Application Name: Dry Creek Aiwohi-Cisco Habitat Restoration

Application Number: 218-8205-16255

By: Union SWCD

Reports: [Aiwahi-Cisco Dry Creek Habitat Restoration IT Comments_Response.pdf](#) - [IT Comments Response](#)

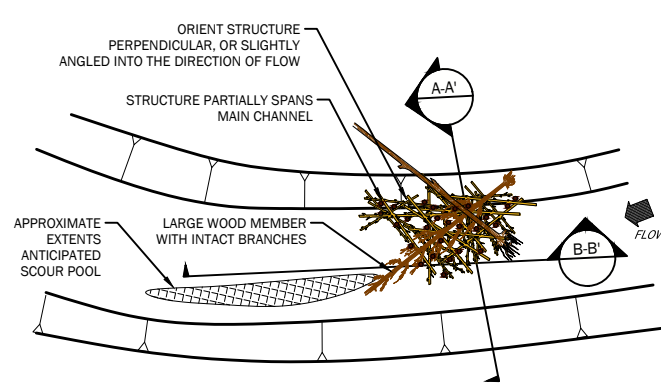
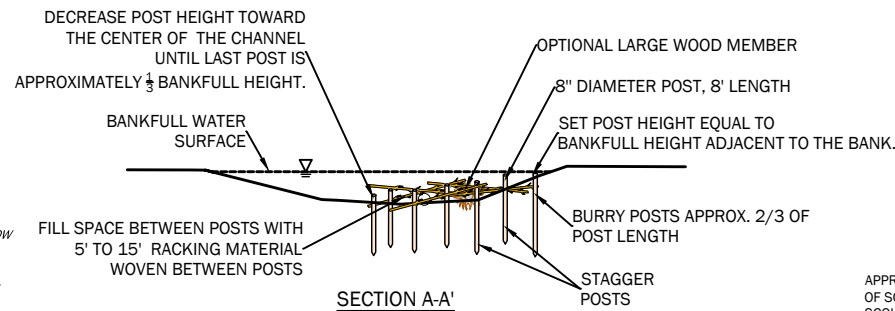
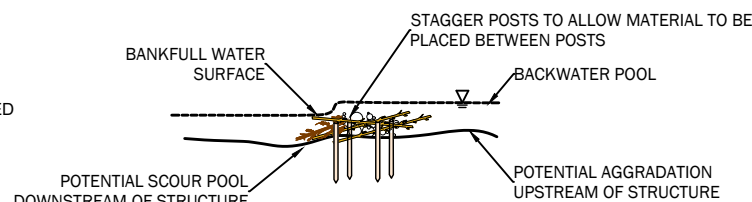
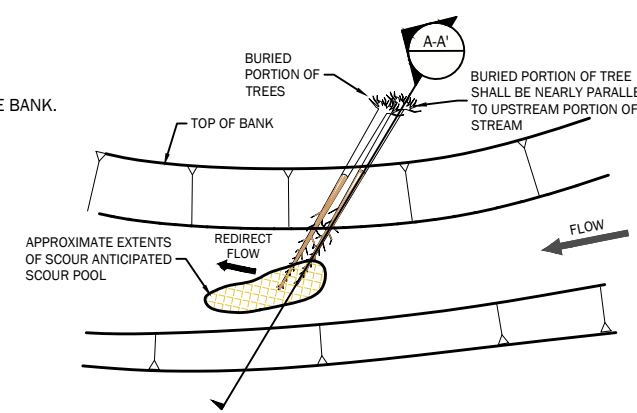
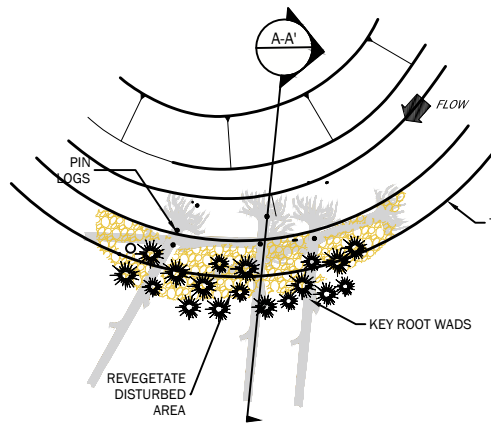
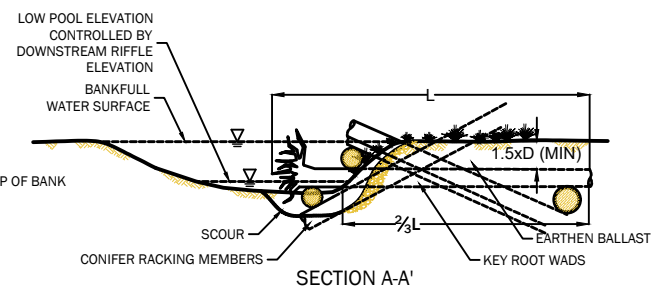
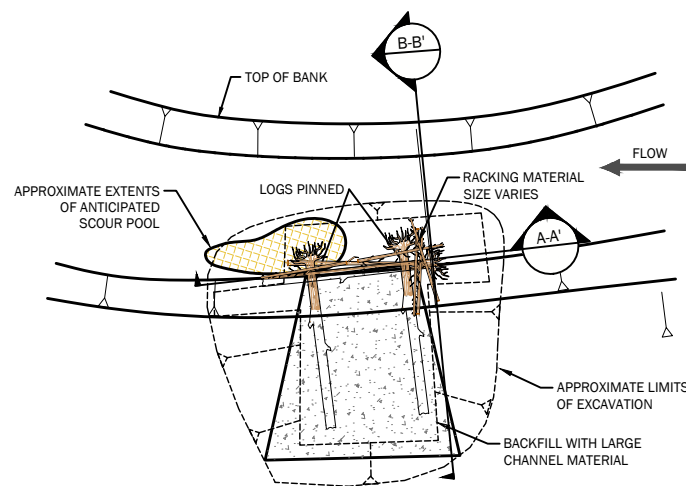
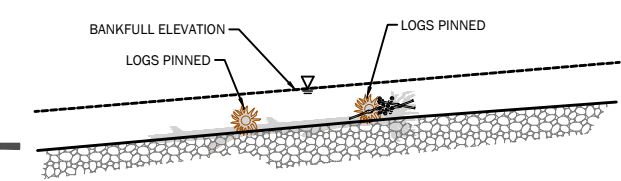
1. Design looks good and includes features proven to be beneficial for higher graded streams. Must wonder if cost-benefit ratio is suitable given this is a tier 3 stream with de-watering and fish passage issues downstream. Project could provide beneficial habitat for steelhead. At this time it would not benefit Chinook until such a time that the passage issues at Royce and Huber diversions are addressed.

The 30% design drawings for typical wood structures intentionally omitted the fine detail of racking and slash material to allow reviewers a clearer view of the base structure. The Final Design planset includes additional detail of structure typicals for a vertical post array, longitudinal logs, and bank rootwad (material specifications provided below). Internal discussions between the District and the engineering firm sought to reduce the budget estimate by decreasing the amount of slash material from 286cy to 130cy, and vertical piles from 340 to 120 for a total cost savings of \$41,810. This was done in order to improve the cost/benefit ratio and balance between function and cost.
